Subject: MHI's Responses to US-APWR DCD RAI No.160-1848 Revision 0

Reference: 1) "REQUEST FOR ADDITIONAL INFORMATION NO. 160-1848 REVISION 0,
SRP Section: 10.04.09 - Auxiliary Feedwater System (PWR), Application
Section: 10.4.9, dated January 21, 2009.

Responses to Request for Additional Information No.160-1848
Revision 0

RAI NO.: NO. 160-1848 REVISION 0
SRP SECTION: 10.4.9 AUXILIARY FEEDWATER SYSTEM (PWR)
APPLICATION SECTION: 10.4.9
DATE OF RAI ISSUE: 1/21/2009

The Tier 1 DCD, Figure 2.7.1.11-2 will be revised as shown below:

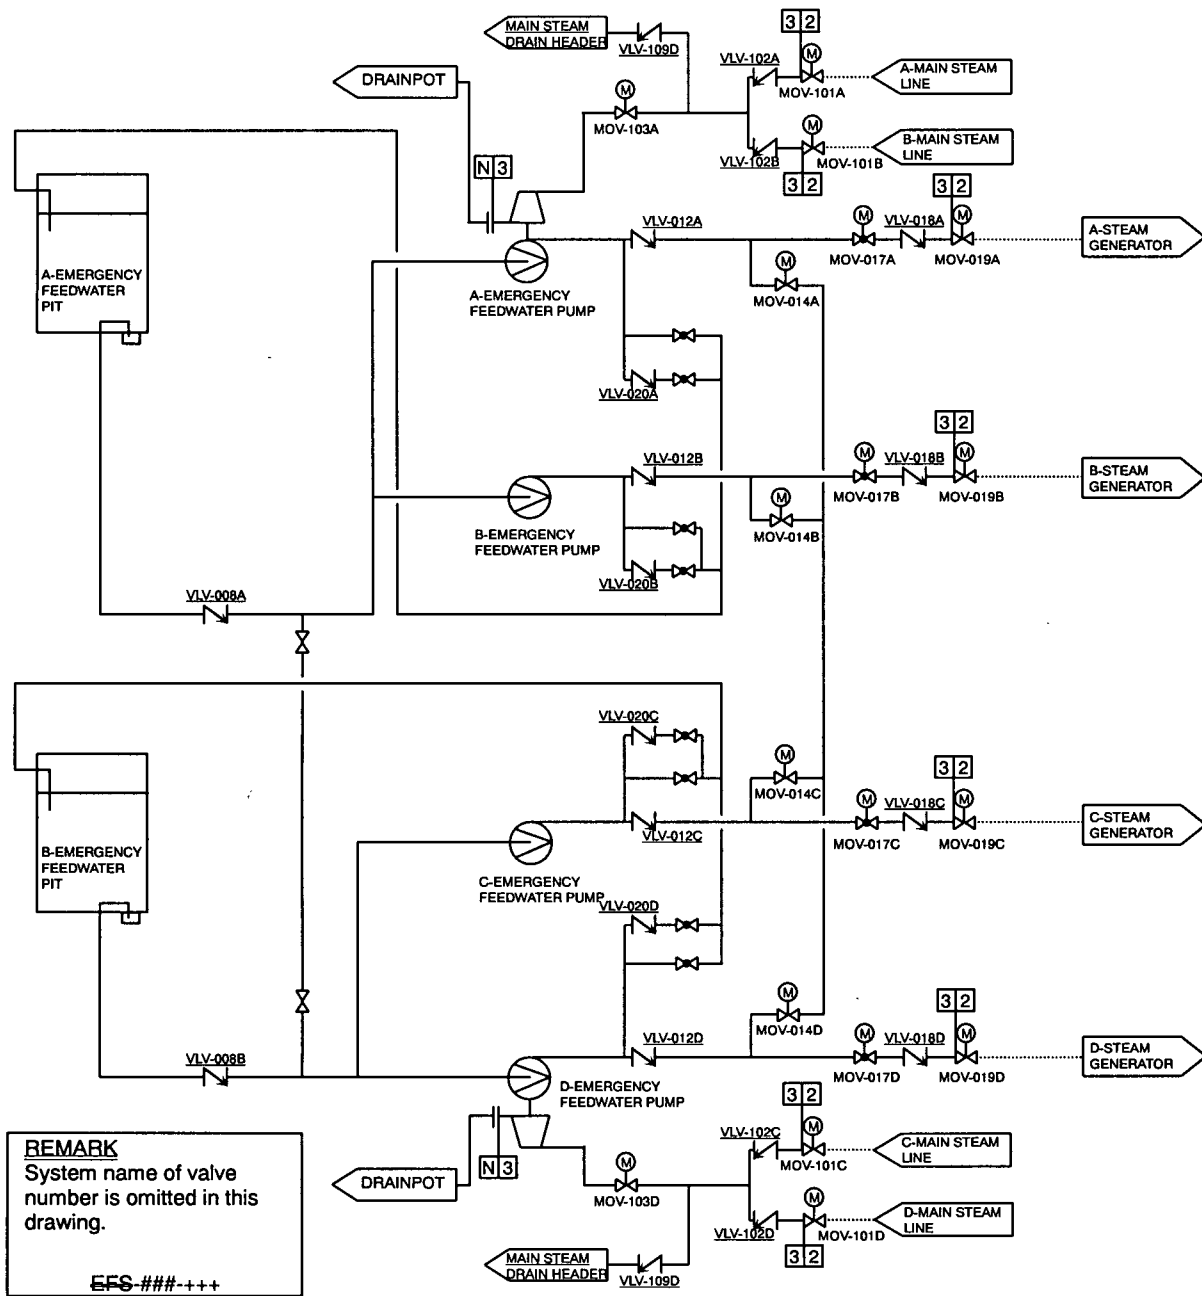
Demonstrate how it will be assured that EFWS check valves will be addressed as part of the ITAAC process, consistent with SRP 14.3, Appendix C, Item II.B.i. Include this information in the DCD and provide a markup in your response, including updates to Tier 1 flow diagrams to explicitly show EFWS check valves that have a safety function.

The check valves with active safety-related function will be added to Table 2.7.1.11-1, Table 2.7.1.11-2, ITAAC shown in Table 2.7.1.11-5 and Figure 2.7.1.11-2 of the Tier 1 DCD. In ITAAC shown in Table 2.7.1.11-5, the testing of the check valves which cannot be practically established includes alternative inspection method (i.e. through disassembly) of the valves. Therefore, ITAAC item 9.a.iii describes that "Tests" of the as-built check valves will be performed for the operation of the valves.

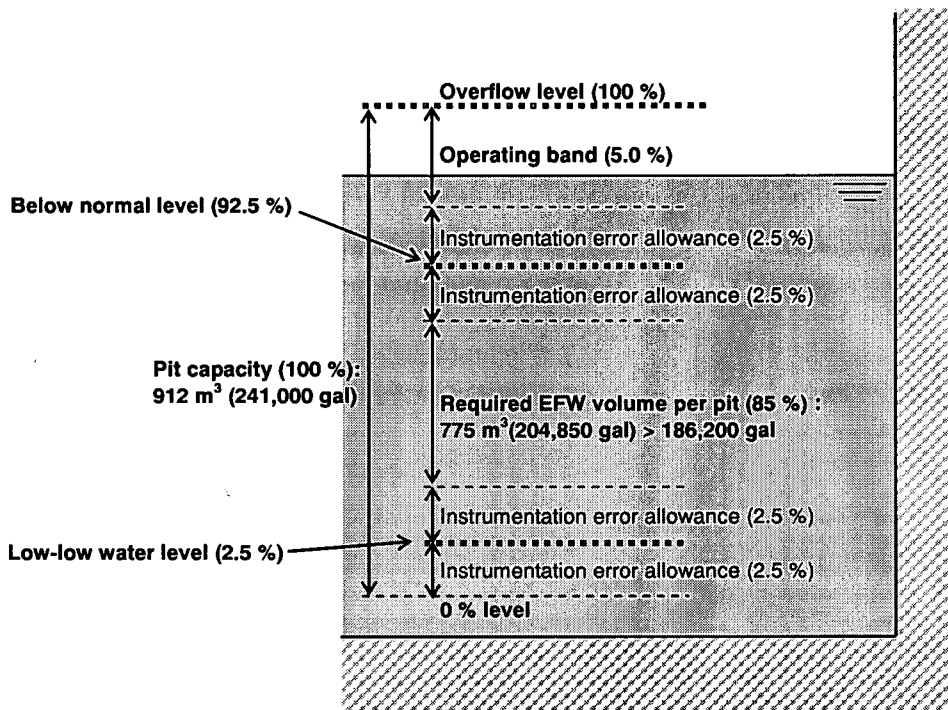
Reconcile the discrepancy between the minimum pit capacity cited in the ITACC and the minimum pit capacity cited in the Technical Specifications and DCD Tier 2 Section 10.4.9.3. Include this information in the DCD and provide a markup in your response.

186,200 gallons described in ITAAC 13 in DCD Tier 1 Table 2.7.1.11-5 is the amount of water per 1 pit of the sum total of the volume of water required for removing the decay heat during the 14 hours, which is the total of 8 hours of plant hot standby and the following 6 hours of RCS cooling to MODE 4 by steam generators (225,900 gallons), the volume of water required to remove the sensible heat during 6 hours of the RCS cooling (62,300 gallons), the volume of water required to restore the steam generator water level during the 14 hours (52,400 gallons) and the volume of water required to remove the heat input from the RCP during the 14 hours (31,800 gallons). On the other hand, the EFW pit is designed such that it is able to ensure 204,850 gallons which takes 10 % margin to 186,200 gallons into account, even when 2.5 % of instrumentation error allowance and 5.0 % of operating band are taken into consideration.

In ITAAC 13 of DCD Tier 1 Table 2.7.1.11-5, it is described to ensure the required value 186,200 gallons itself, however, in the actual inspection, as is shown in the figure below, if it is confirmed that the EFW pit water level is greater or equal to 92.5 % which is the below normal level, even if instrumentation error allowance is taken into account, it can be confirmed that the volume of water which has margin to 186,200 gallons (204,850 gallons) is ensured.
